Response to U.S. EPR Design Certification Application RAI No. 222, Supplement 1

Request for Additional Information No. 222, Supplement 1

U. S. EPR Standard Design Certification

Question 03.08.03-18:

Figure 03.08.03-18-1—Wireframe View of the RBIS Model Illustrating the Fixed Boundary Condition Nodes (Highlighted in Black)

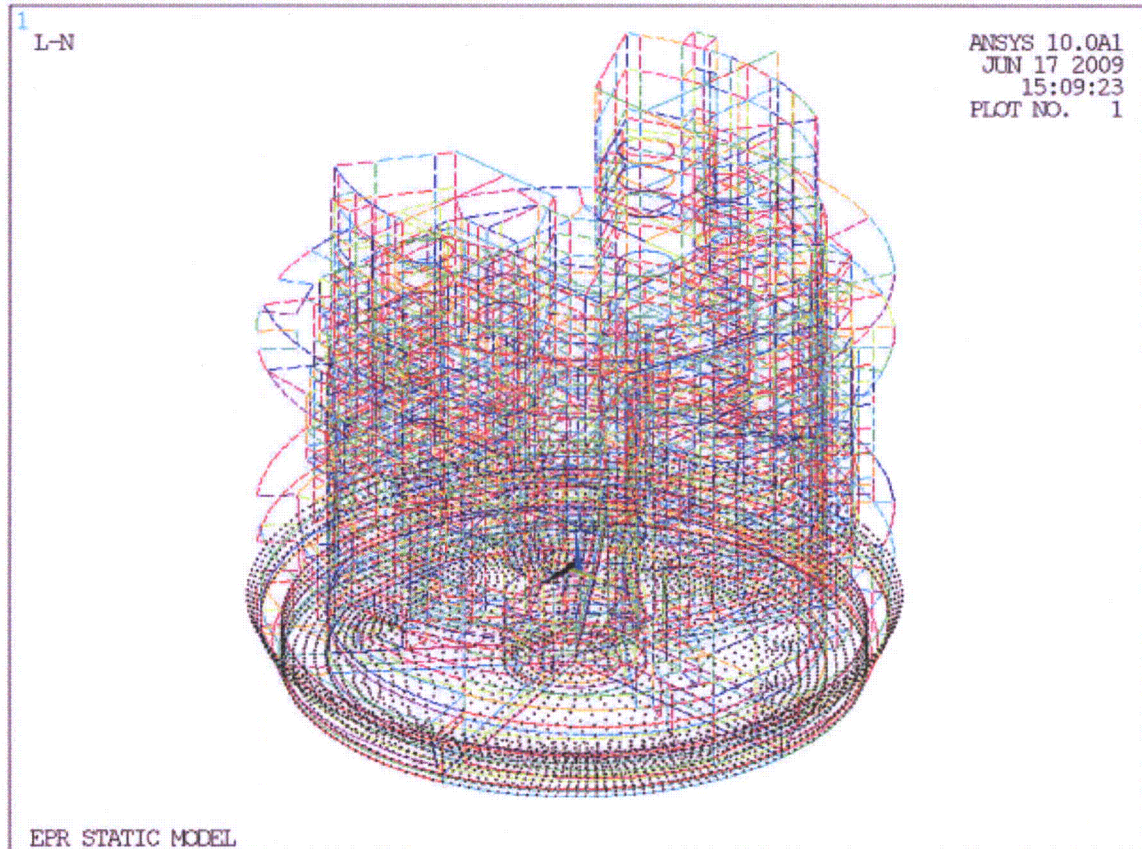
- a) One or more DVDs containing the ANSYS (.db) and the input (.txt) files to create the ANSYS (.db) file for RBIS truncated model, including all boundary condition files. This model corresponds to the FEM model described in US EPR FSAR Section 3.8.3.4.1 and shown in Figures 3.8-32 through 3.8-37.

- a) Enclosed to this response is a DVD containing the following files:
- The file Batch_Run_Create_RBIS_Fixed.txt is used to create the Reactor Building Internal Structures (RBIS) model. This file begins by resuming the database NI_GEOMETRY_ONLY.db, which contains the geometry of the full static model.
 - The file Batch_Run_Create_RBIS_Fixed.txt truncates the full static model so that only the RBIS remains. The file then reads in the zero period acceleration (ZPA) and ZPA

modification factor values, which are provided in the files ZPA_values_SC01.txt and ZPA_modification_factors_SC01.txt, respectively (values are taken from soil case SC01 as per Part b of this response). The batch file applies fixed boundary conditions to nodes along the bottom of the RBIS and along the haunch walls. The black nodes shown in Figure 03.08.03-18-1 are fixed for all degrees of freedom by calling the subroutine Boundary_Conditions_RBIS_Fixed.txt.
